GOVERNMENT/INDUSTRY AERONAUTICAL CHARTING FORUM
Instrument Procedures Group
April 18, 2006
HISTORY RECORD

FAA Control # 06-01-264

Subject: Uniform Standard for use of Climb Gradients on Public IAPs

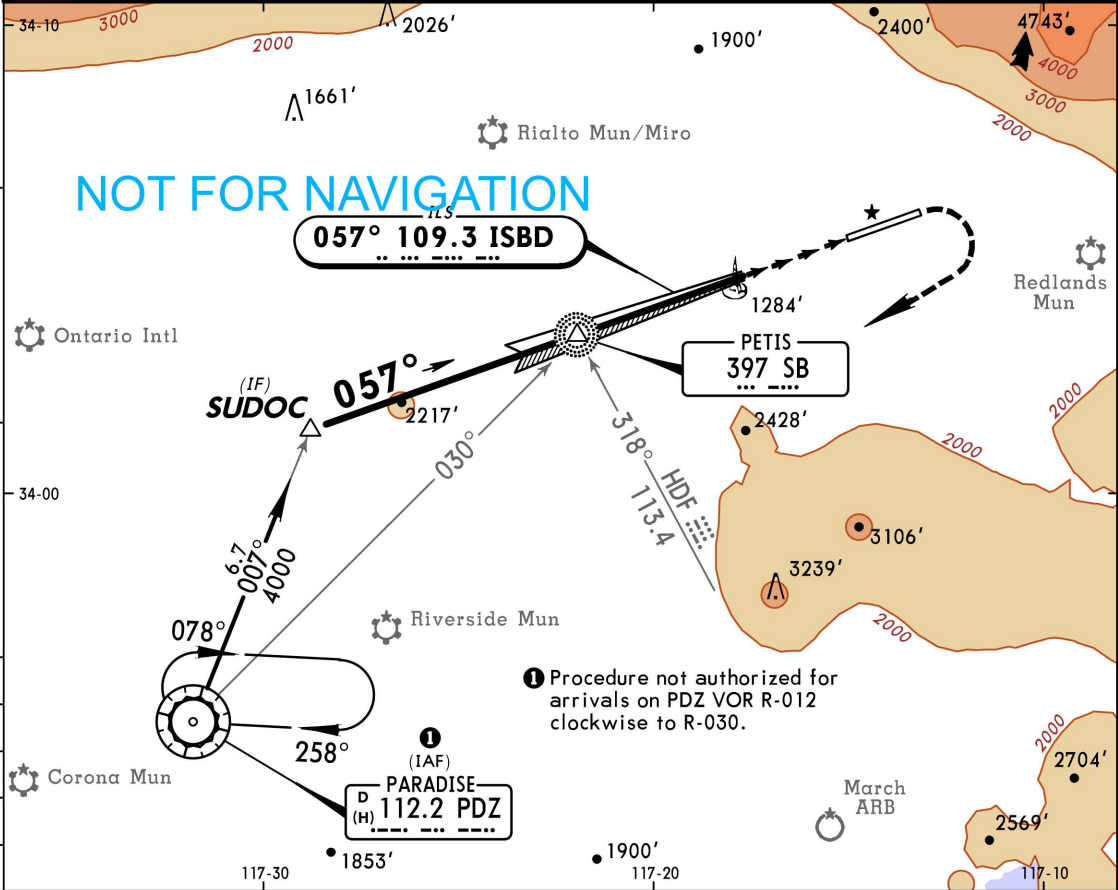
Background/Discussion: The FAA recently charted a public SIAP at San Bernardino (KSBD, ILS Runway 6) (Exhibit #1 attached) with a 280-FPNM climb gradient (CG) specified to 5,000 feet MSL (4,009 feet above TDZ elevation). The only public precedent for this is a long-standing higher-than-standard missed approach slope for the Burbank (KBUR) ILS Runway 8 (Exhibit #2 attached). KBUR is charted in a fundamentally different manner than KSBD in that rate-of-climb is charted instead of CG, and reference is made to use the KBUR LOC Runway 8 (Exhibit #3 attached) in the event the ILS' missed approach cannot be complied with. Use of rate-of-climb as a procedural data value is archaic and inconsistent with FAA national policy. Some pilots convert CG to rate-of-climb others use AFM performance data and OEM profiles to assure CG compliance. Further, some pilots use a missed approach speed that is not available on the KBUR ILS 8 SIAP rate-of-climb table.

The CG on the new KSBD SIAP was granted by a Flight Procedures Standards Waiver, which asserts that an equivalent level of safety will be achieved simply by charting the CG. The waiver states, *"The climb gradient will be published on the procedure in feet per nautical mile which will permit users to calculate their climb requirements upon other factors."* NBAA submits: (1) This does not provide an equivalent level of safety, (2) Does not comply with standard international practices (See Tarbes, France (LFBT) VOR/ILS Runway 20 [Exhibits #4 and #5 attached]), which similar such international procedures contain at least two line of minima, one predicated on standard missed approach surfaces, and the other (or others) based on steeper-than-standard missed approach surfaces; and, (3) Lacks reasonable guidance to pilots, which could be remedied by pertinent information via the AIM (preferred) or briefing attachment to the SIAP.
